Service Advisory

CC-521

Subject: **ANCHOR POINT FAILURE ON DECK**

PURPOSE: To provide a stronger anchoring point for the deck belt idler spring.

FIGURE 1

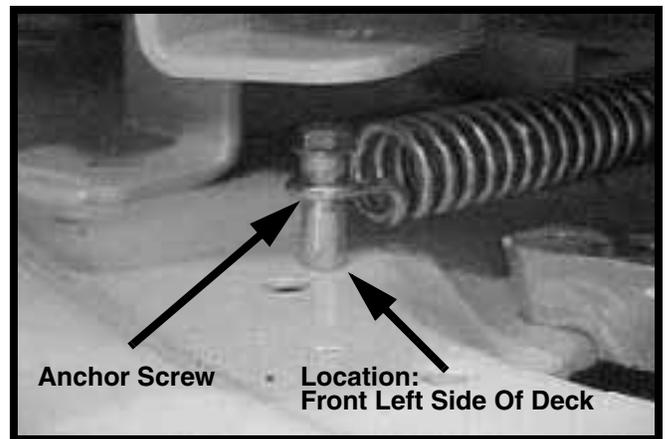
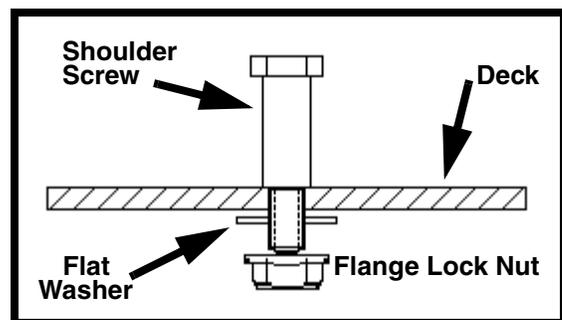
3. Locate the spring anchor on the front left side of deck as shown in FIGURE 1. The original anchor consist of a 1/4” self tapping screw (710-0778) with a spacer sleeve (750-0566A) over the screw.

4. Remove the spring from the anchor screw and sleeve using a spring puller tool if anchor screw is still attached.
5. If anchor screw is still attached remove and discard 1/4” self tapping screw and spacer sleeve.

6. Use a 1/4” drill bit and drill to enlarge the hole that the 1/4” self tapping screw was removed or missing from.
7. Check the under side of the deck. It may be necessary to remove the deck extrusion material from around the hole by grinding. The surface at the mounting hole needs to flat on both top and bottom of the deck.

8. Install shoulder screw (738-0560) from the top with the flat washer (736-3090) and flange lock nut (712-04064) from the underside. Tighten securely.

9. Attach the tension spring onto the new shoulder screw anchor point.
10. Reinstall deck and test run unit for proper operation.
